TECHNICAL MEMORANDUM

TO: Mr. Robert Miller, Wallace Group DATE: May 3, 2010
FROM: Peter M. Pyle, P.G., CHG. JOB NO: 2323
RE: Peer Review of the Los Osos Groundwater Model

Figure 6
Cumulative Departure Curve
Los Osos Station 197 (South Bay Fire Dept.)

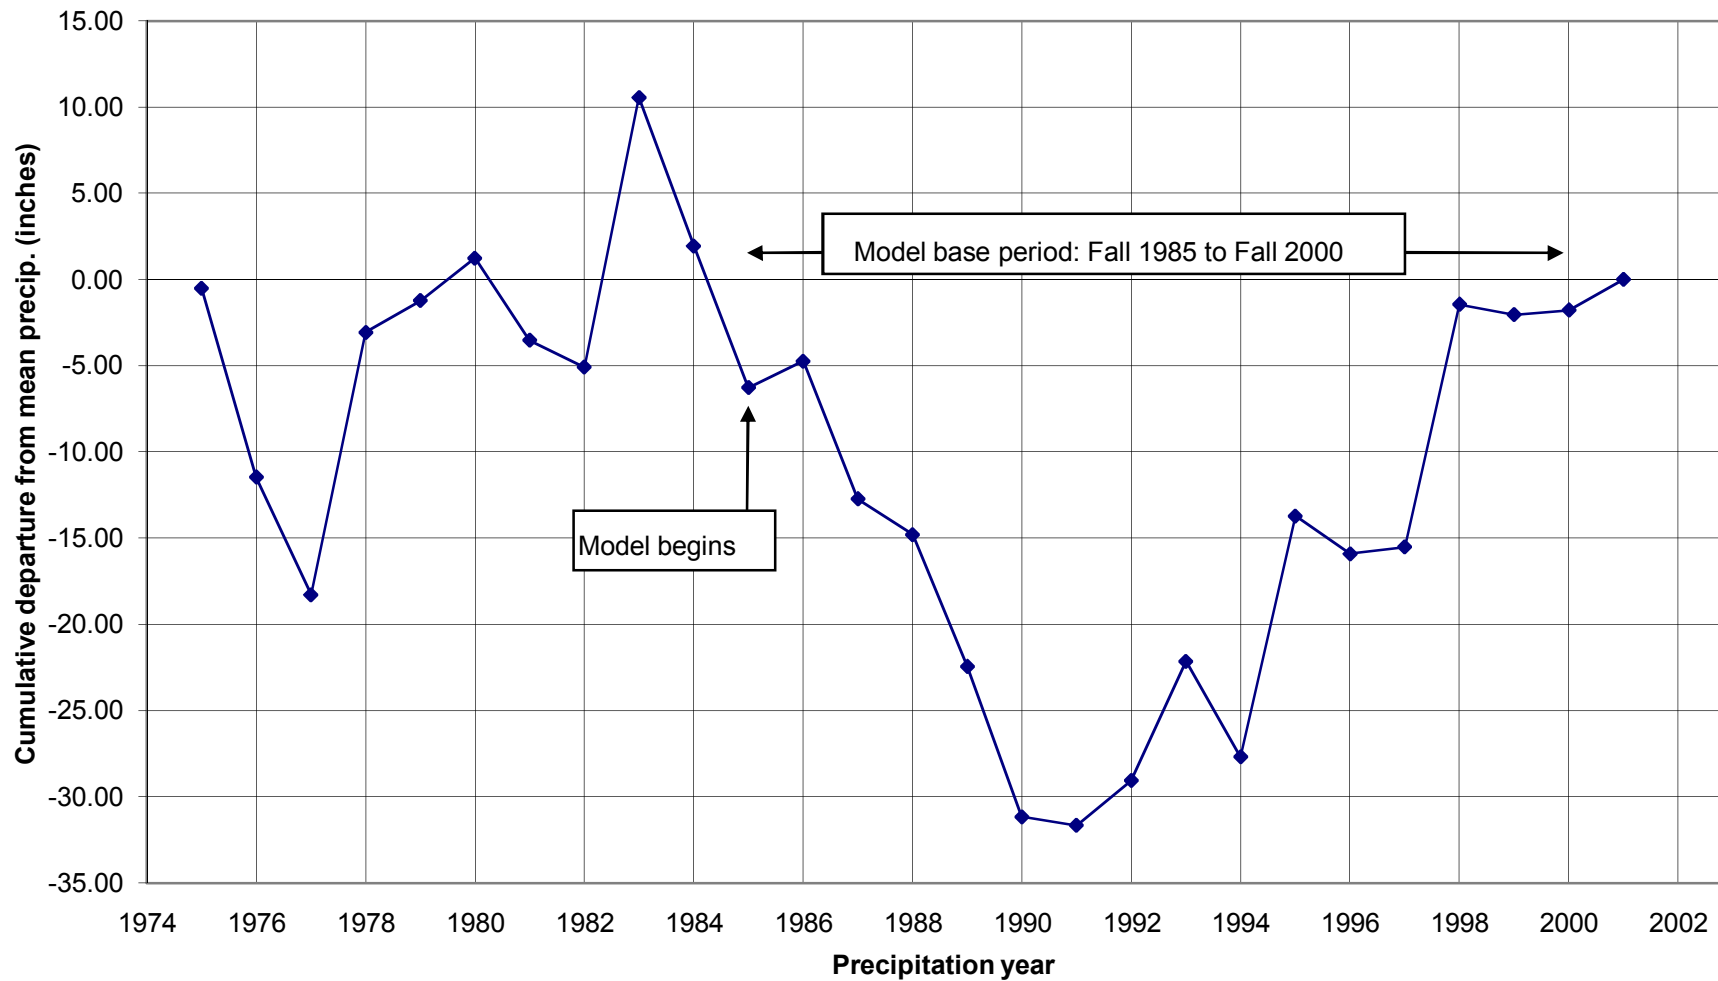
In order to evaluate whether the RIV module was properly used to represent Los Osos Creek seepage, two analyses were performed. For the first, Creek flow data and a precipitation graph with a cumulative departure curve was requested from CHG. The Creek flow data is shown in Figure 5. It shows that data is missing for 1983, a wet year, and 1985-93 most of which were dry years. The wet or dry year condition was determined using long term precipitation data with a cumulative departure curve requested from CHG (Figure 6). A comparison of Figures 5 and 6 indicate the creek flow data is skewed to wet years.

The average creek flow for all of the years shown is 3,940 afy with a median of 2,230 afy. If a balance period is selected (Figure 6) which is limited to 1979-81 creek flow data (Figure 5), the average is 2,326 afy with a median of 1,630 afy. This suggests that no more than about 1,600 afy should be allowed by the model to seep from the stream to the underlying aquifer. The results of the increased pumping in the Los Osos creek subarea by CHG (2009b) is well within this limit at 1,013 afy. In addition, the gage from which the flow data in Figure 5 was obtained is located somewhat downstream from the basin and model boundary such that some seepage to the aquifer can occur in the groundwater basin upstream of the gage. The STR package will allow more accurate representation of stream leakage in future revisions of the model.

Figure 7. Zone D, measured and simulated extent of seawater intrusion, 2005.
(modified from Figure A3, CHG, 2009b)

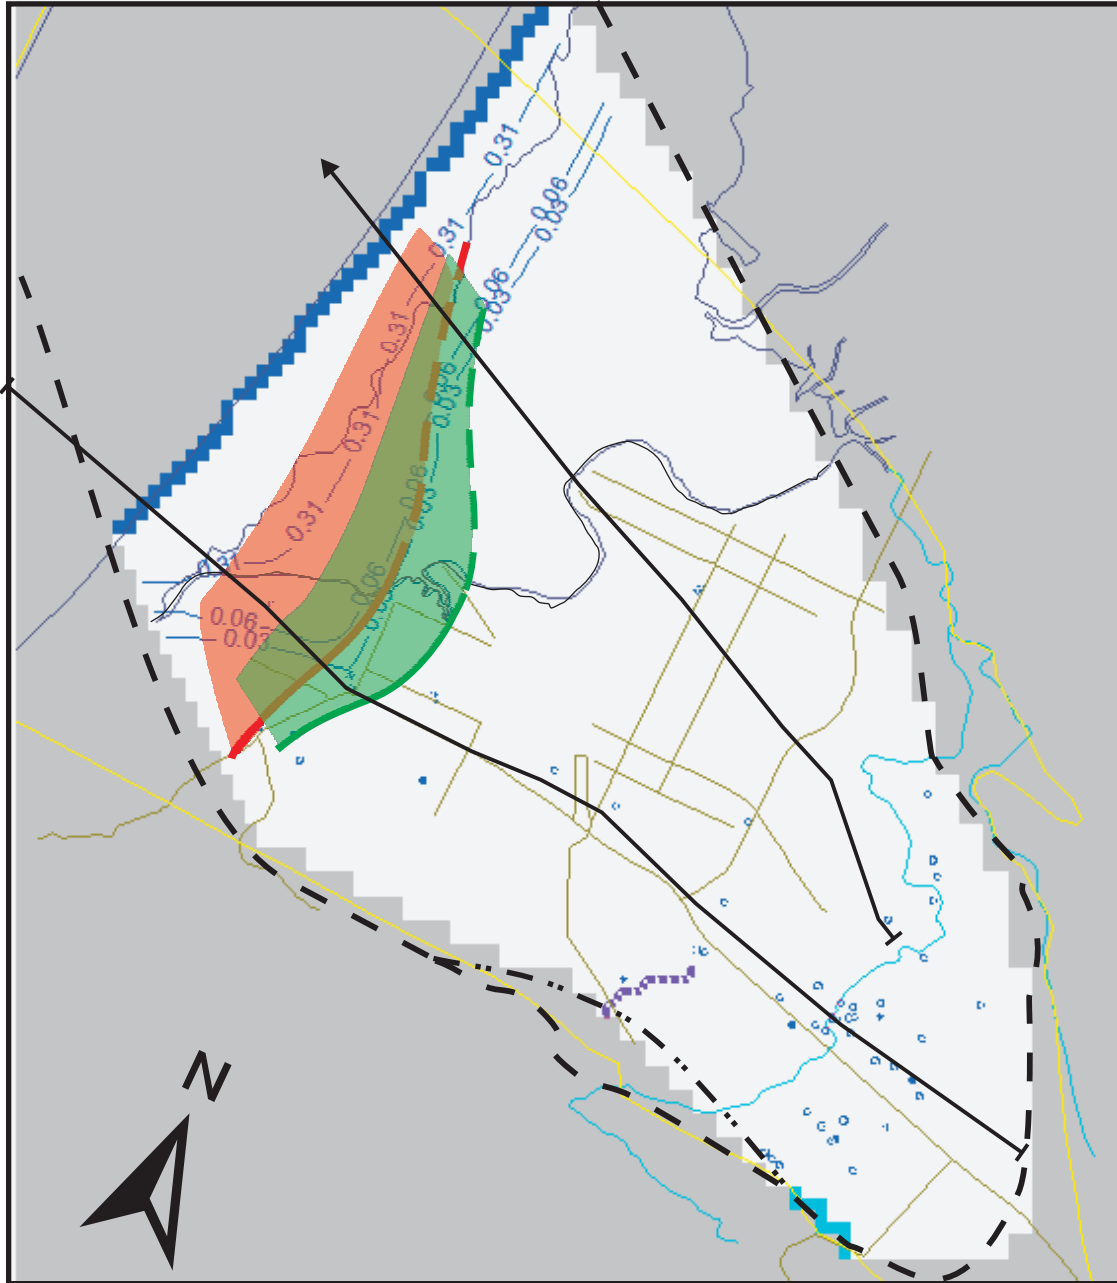
In addition to the analyses discussed above, Stetson Engineers requested that CHG provide a composite map of the simulated and measured extent of seawater intrusion as of 2005, the end of the 50 year calibration period to determine visually how well the model matches the data base on the 250 mg/l Chloride isochem. Figure 7 shows the results provided by CHG where the green

area represents the 250 mg/l Chloride isochem as a wedge in Zone D due to density differences and the blue line (0.03 isochem) represent the model simulated extent of the 250 mg/l Chloride isochem in the middle of the aquifer. The model appears to match the data relatively well. A comparison of columns 2 and 3 in Table 1 provides a more precise measure of this difference.
